UNITED STATES PATENT AND TRADEMARK OFFICE

APPLICATION NO.	FILING DATE	FIRST NAMED INVENTOR	ATTORNEY DOCKET NO.	CONFIRMATION NO.
09/929,488	08/15/2001	Kimikazu Matsumoto	250901/00	1362

Office Action Summary

DETAILED ACTION

FIG. 1A(PRIOR ART)

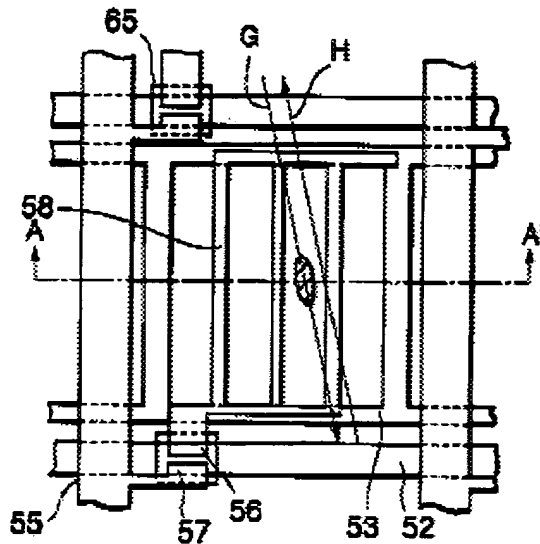
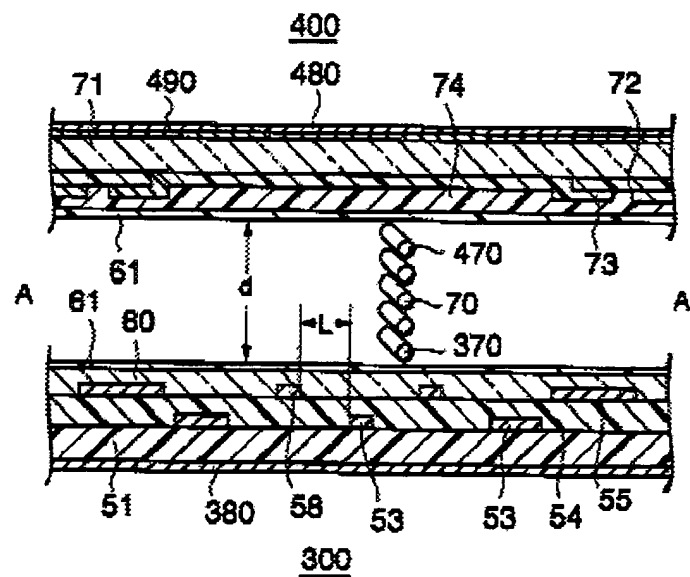
As to claims 8 and 9, Baur does not explicitly disclose a display wherein a gate wiring of a thin film transistor is formed on said first substrate simultaneously with said common wiring and wherein an island disposed above said common wiring and made of a semiconductor film is formed in said insulating film, and said island constitutes an active region of a thin film transistor. However, these are merely common knowledge means of comprising a satisfactory TFT display configuration.

Applicant's admitted prior art (APA) discloses these claimed features in Applicant's Figures 1A and 1B to comprise a satisfactory TFT display configuration.

APA is evidence that ordinary workers in the art of liquid crystals would find the reason, suggestion, or motivation to add a display wherein a gate wiring of a thin film transistor is formed on said first substrate simultaneously with said common wiring and wherein an island disposed above said common wiring and made of a semiconductor

FIG. 2

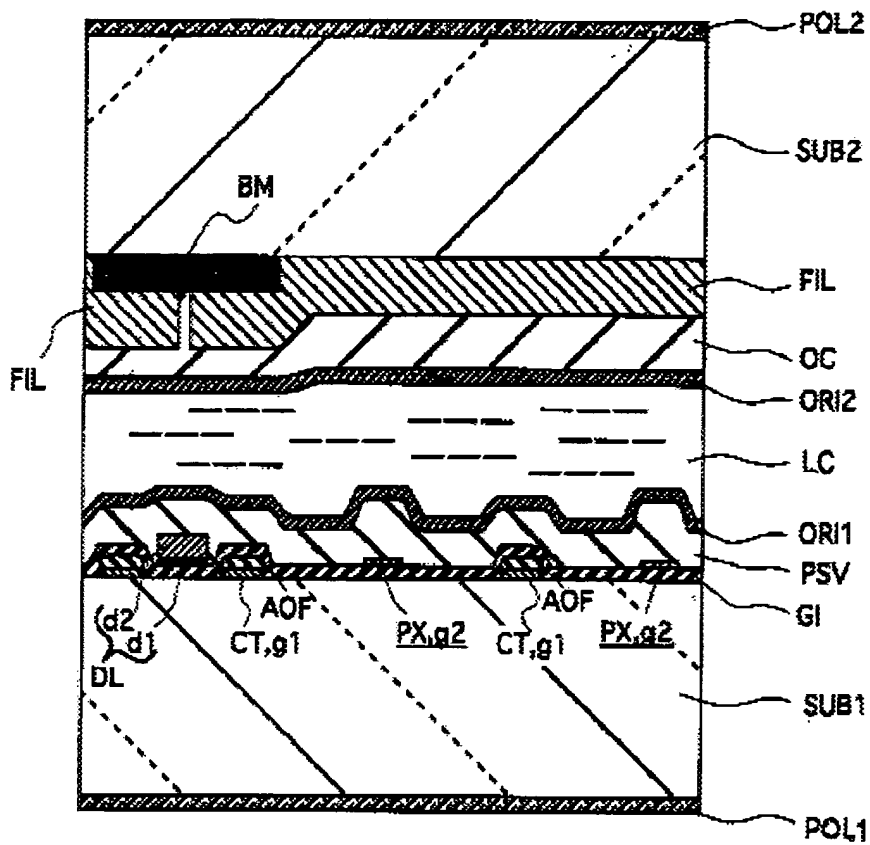
As to claims 8 and 9, Baur does not explicitly disclose a display wherein a gate wiring of a thin film transistor is formed on said first substrate simultaneously with said common wiring and wherein an island disposed above said common wiring and made of a semiconductor film is formed in said insulating film, and said island constitutes an active region of a thin film transistor. However, these are merely common knowledge means of comprising a satisfactory TFT display configuration.

Ohta discloses these claimed features in Figures 2 and 3 to comprise a satisfactory TFT display configuration with *inter alia* wide viewing angle (Abstract).
